# HOLOMUA

1315 KALĀKAUA AVENUE, HONOLULU, HAWAII

FINAL ENVIRONMENTAL ASSESSMENT  
&  
CHAPTER 201H, HAWAII REVISED STATUTES APPLICATION

AUGUST 2008

Figure 2  
Rendering  
**Holomua**

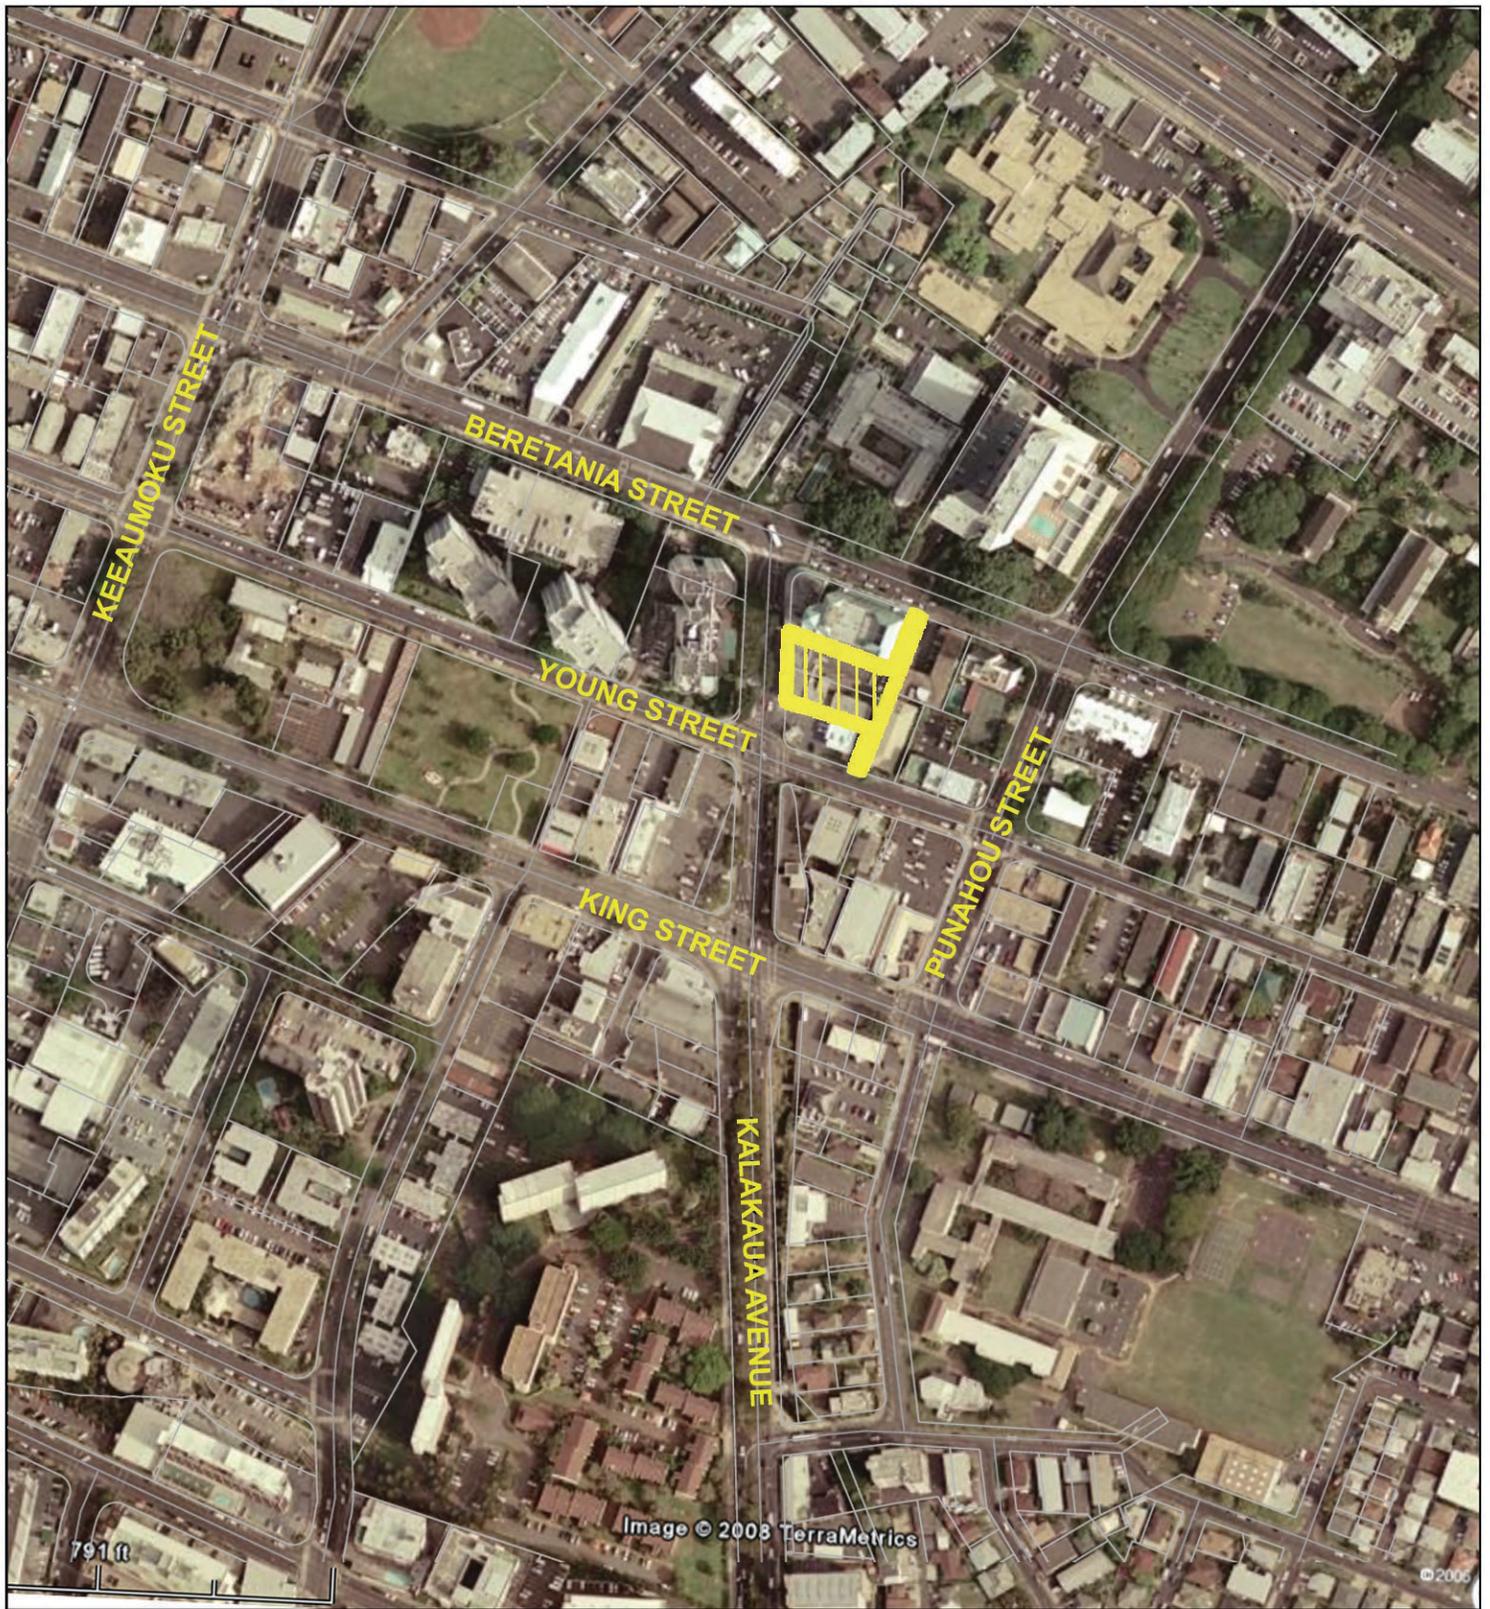
In addition to the significant concerns raised below, we note that the rendering in Figure 2 of the draft Environmental Assessment is erroneous, depicting our building (Kulana Hale) as a solid wall, when, in fact, Kulana Hale consists entirely of windows facing the proposed Holomua Project—all of which will be a mere 20 feet away from the Holomua construction, eight stories of parking (or solid wall) and Holomua's building.

**Rendering (Figure 2).** We acknowledge that the rendering in Figure 2 does not provide any building detail relative to Kulana Hale 1. The purpose of the rendering was to show Holomua's architecture. Regarding your concern about the distance between Kulana Hale and Holomua, Holomua is designed as a residential tower atop a parking structure pedestal. The residential tower walls (including the north wall facing Kulana Hale) are setback from the parking structure and are articulated with jogs, building insets, windows, and lanais. This allows 30 to 40 feet between Holomua and Kulana Hale from the 9<sup>th</sup> floor up. In addition, as part of the Final EA, we have included a visual analysis which provides a three-dimensional view of Holomua, showing the building in context with the surrounding structures.

TYPICAL PARKING LEVEL PLAN - LEVELS 3, 4, 5, 6 & 7

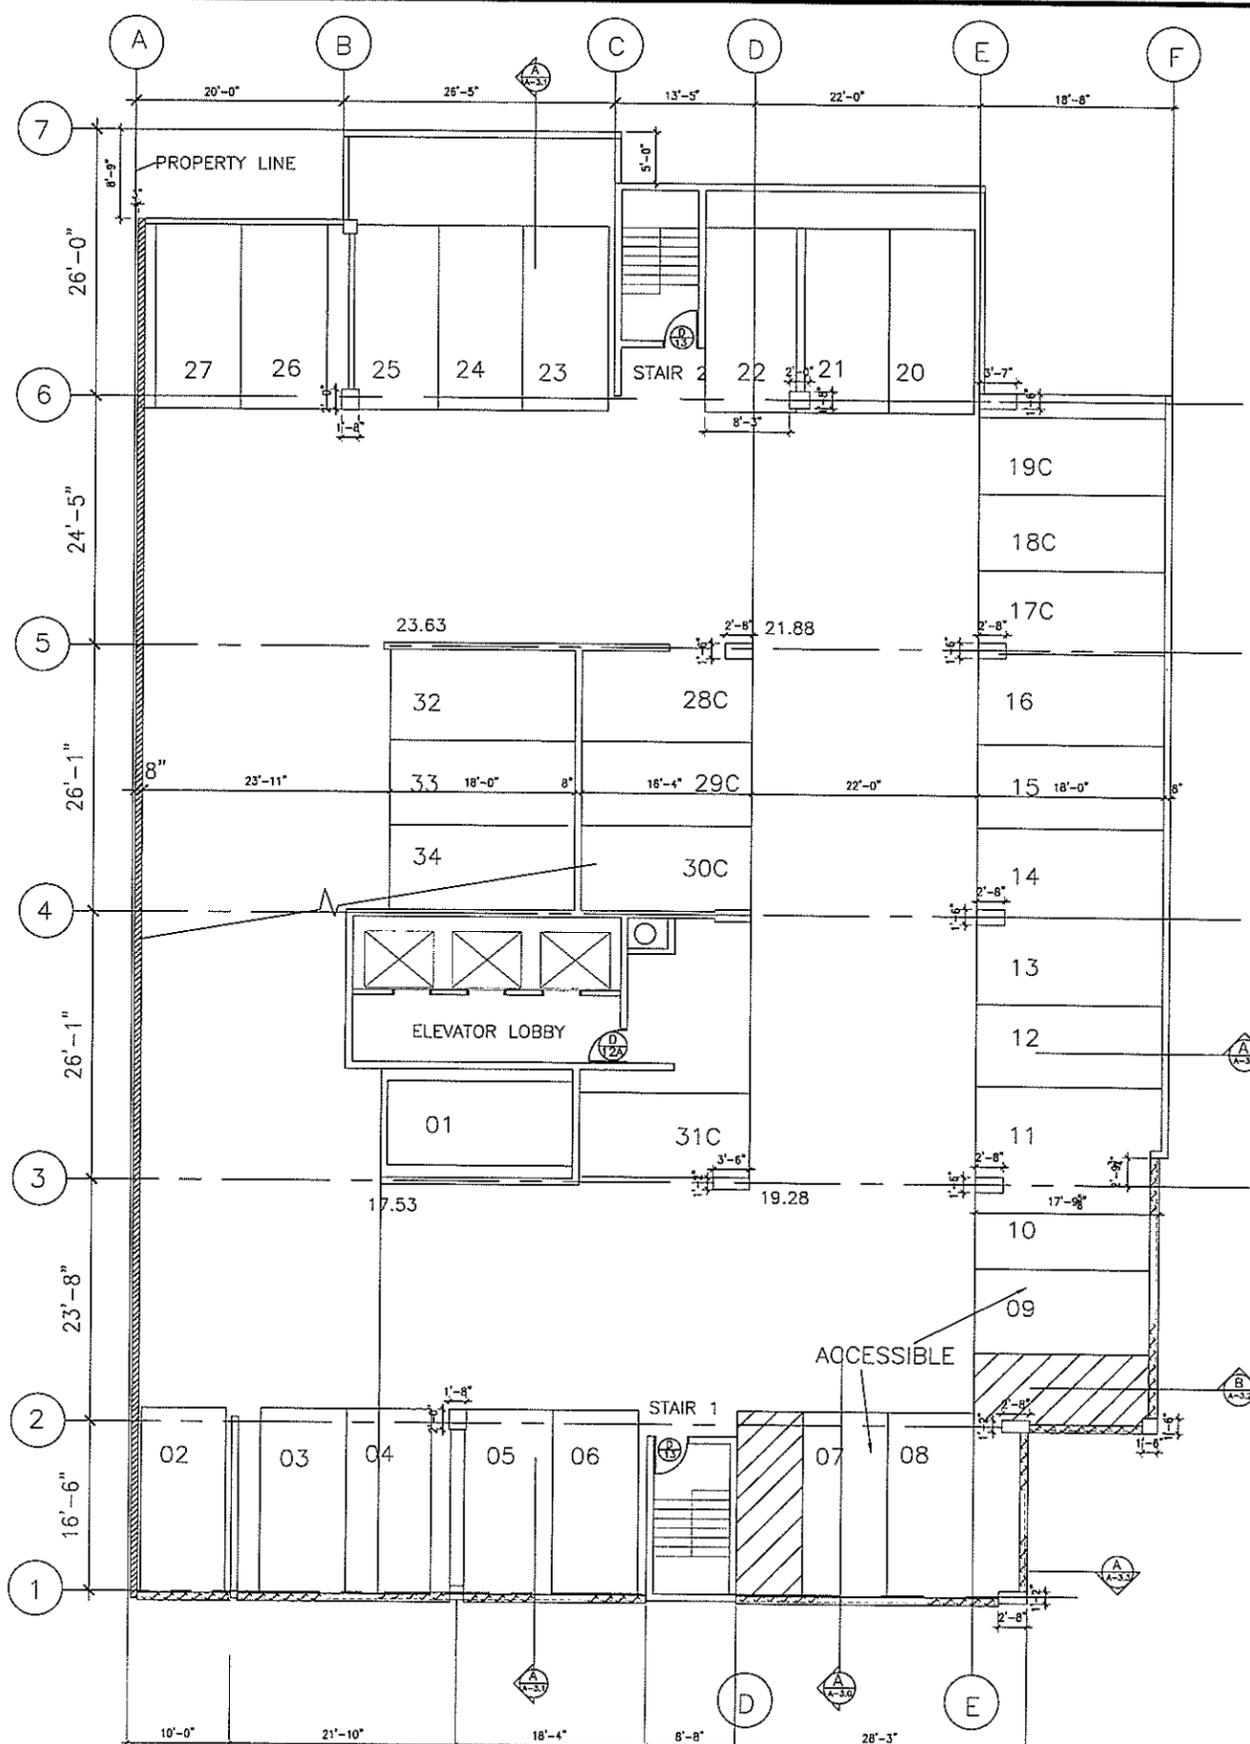
1. The provided parking spaces and/or areas must meet minimum LUO standards. Maneuvering areas must be clearly shown. (See Sheet A-2.0 & A-2.1)
2. All required yards shall be landscaped. All planted material and landscaping shall be provided with a permanent irrigation system. Complete landscape plans required.

6. Specify the aisle width between the left exterior wall and the elevator core (see Sheet A-2.0). Explain how vehicles can get around the elevator core that encroaches into the parking aisle.

1. As discussed above, the plans included in the Draft EA provide for 245 parking stalls. As discussed in the Draft EA, THM Partners LLC requests the option to include a lesser number of 201 resident parking spaces (1.14 stalls/unit) and 10 guest parking stalls for a total of 211 parking stalls. Please note that unit plans and parking structure design are not finalized and additional changes regarding parking may be required; however it is envisioned that Holomua will provide at least one stall per unit. Maneuvering areas are shown on Sheets A-2.0 and A-2.1.

7. Within the parking structure a 20-foot clear vehicle aisle is provided between the elevator bank and the north wall.
8. Floor area calculations were provided in the Draft EA (see Sheet A-0). The Draft EA proposed a floor area ratio (FAR) of 7.2; current plans, which will be included in the Final EA, propose a slightly higher FAR of 7.5. We acknowledge that this is a greater FAR than Kulana Hale II (6.5 FAR), however the applicant has designed Holomua to address current financial realities, such as the cost of land in urban Honolulu and current building material and construction costs. It is also notable that while the floor area of Holomua is greater than Kulana Hale II, the unit count is similar, with 14 more units, representing a similar density and potential number of residents. In light of the affordable housing provided by Holomua, THM Partners LLC finds the proposed density reasonable.

**A SECTION**  
 A-3.1 SCALE: 3/32" = 1'-0"  
 6/28/08

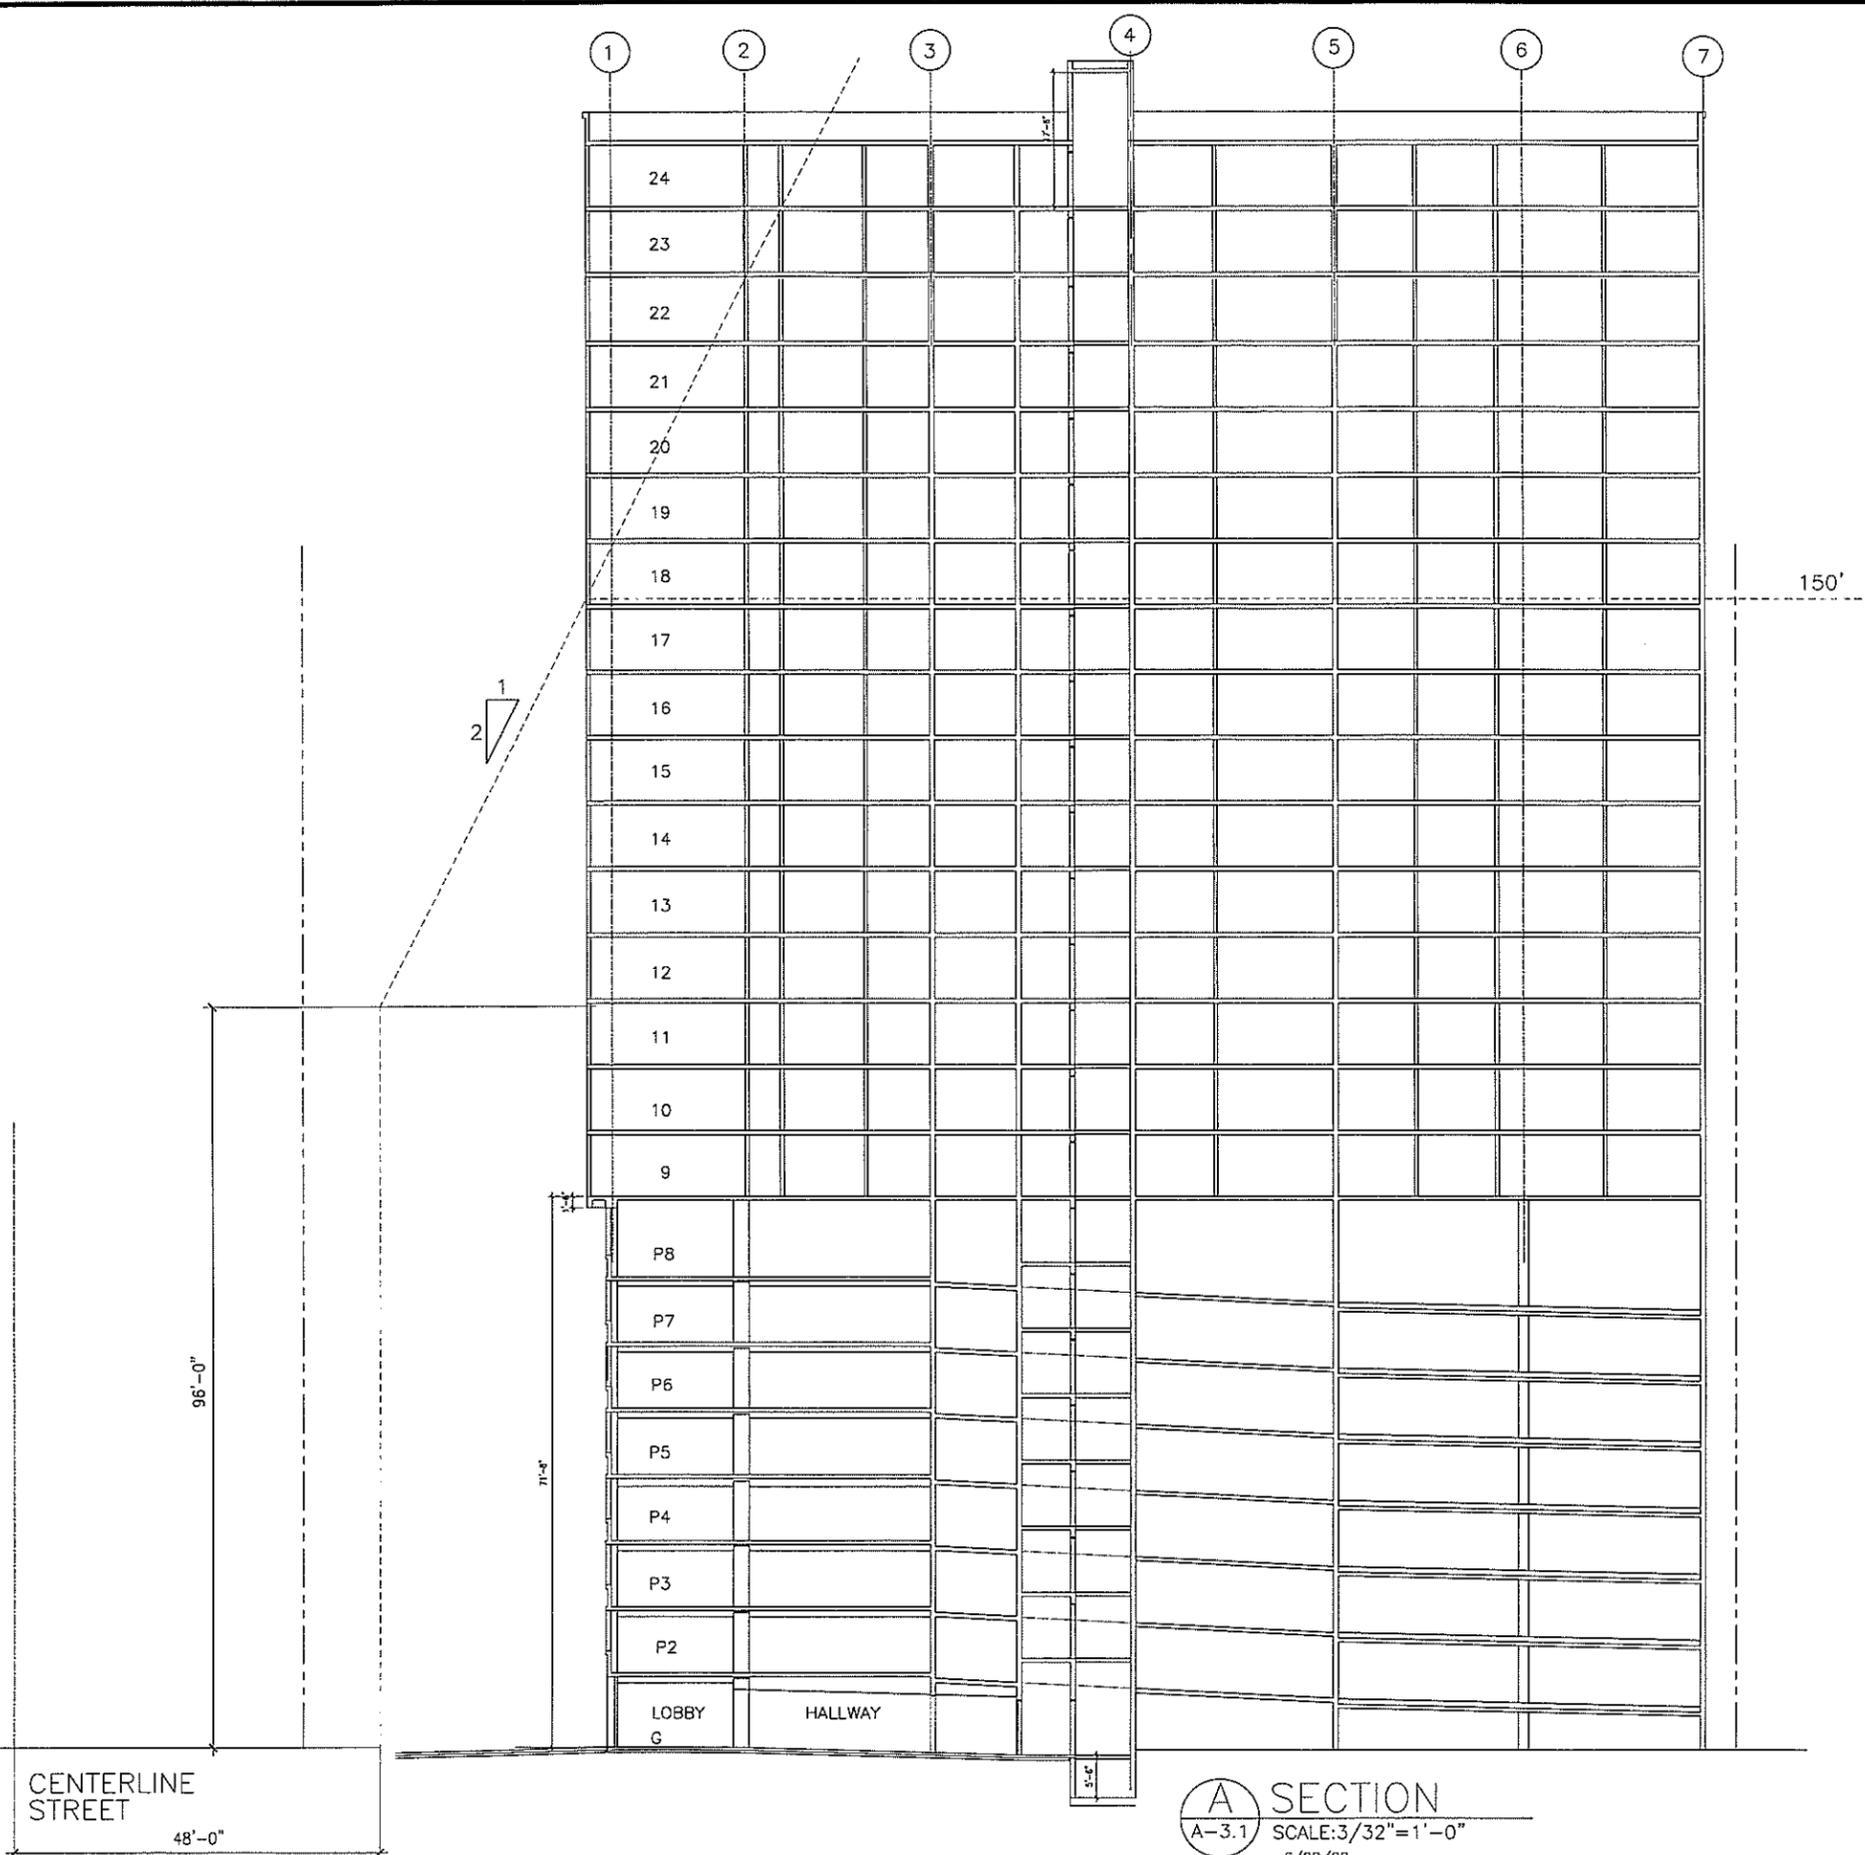
The street setback (height limit) is correctly identified as 60 feet x 30 feet. It should be noted that this encroachment is between the 18<sup>th</sup> floor and roof of the building as shown on Sheet A3.0 of the architectural plans.
